UNITED STATES PATENT AND TRADEMARK OFFICE

APPLICATION NO.	FILING DATE	FIRST NAMED INVENTOR	ATTORNEY DOCKET NO.	CONFIRMATION NO.
10/806,720	03/23/2004	Diane Ransom	04-007-DR	2656

Office Action Summary

DETAILED ACTION

FIG. 4

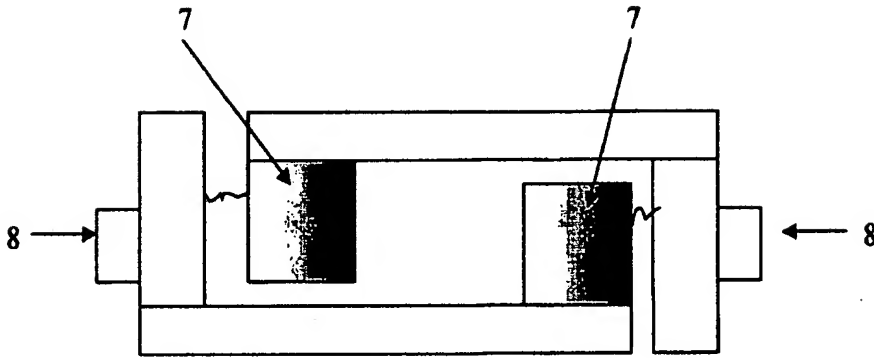
The drawings filed on 19 September 2005 have not been approved for entry due to New matter presented in the proposed Figs. 4 and 5. The structure represented in Figs. 4 and 5 has not been supported in the originally filed disclosure.

The amendment filed on 15 September 2005 (cert. of mail date) is objected to under 35 U.S.C. 132(a) because it introduces new matter into the disclosure. 35 U.S.C. 132(a) states that no amendment shall introduce new matter into the disclosure of the invention. The added material which is not supported by the original disclosure is as follows: Figures 4 and 5, and the amendments to the Specification filed therewith (see page 2 of applicant's filed amendment) referencing Figs. 4 and 5.

1) Applicant has not demonstrated that the details shown in new Figs 4 and 5 were exclusively well known in the button (i.e., garment fastener) art. Applicant has not provided an factual evidence to support the details shown in new Figs 4 and 5 were exclusively well known in the button (i.e., garment fastener) art.

3) Applicant has not submitted factual affidavits under 37 CFR 1.132 or cited references to show what one skilled in the art knew the details provided in Figures 4 and 5 at the time of filing the application.

*Do not Enter -
New Matter -
Not Approved*

Applicant is required to cancel the new matter in the reply to this Office action.

FIG. 6

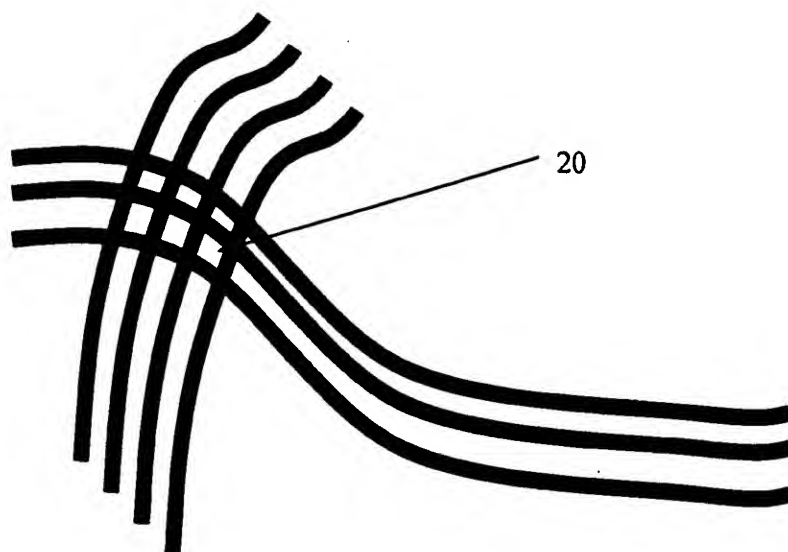
In view of applicant's submission of new drawing Figs. 6 and 7 including drawing features pertaining to "a piece of apparel" (claim 20), "inserting said post through a pre-existing opening in the fabric" (claim 21), and "a plurality of fibers" (claim 22), these specific drawing objections indicated in the prior Office action have been withdrawn.
